**Nuclear Energy Institute
International Event Scale Meeting
June 25, 2003**

Overview

PWR Typical Technical Specification Activity Example Curve

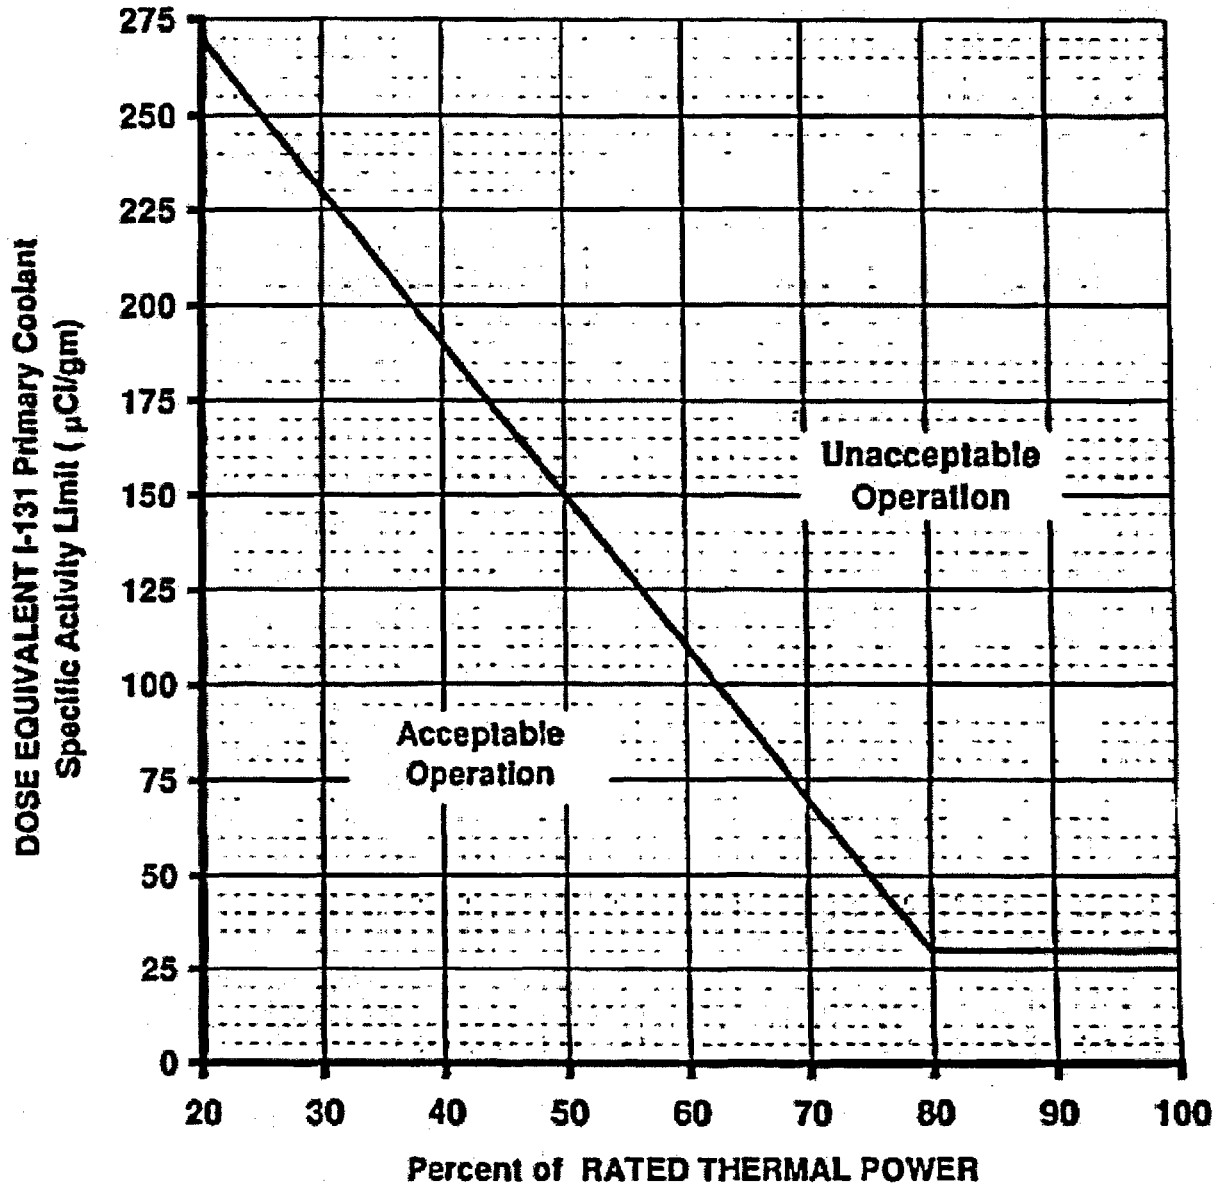
DEI elevated into the Unacceptable Operation region of the Technical Specification transient limit requiring shutdown.

DEI elevated into the Allowable Operation region of the Technical Specification transient limit for greater than the specified action statement time limit requiring shutdown.

DEI elevated out of normal Technical Specification operating limit but returned to within normal operating limit within specified action statement time limit with no shutdown required
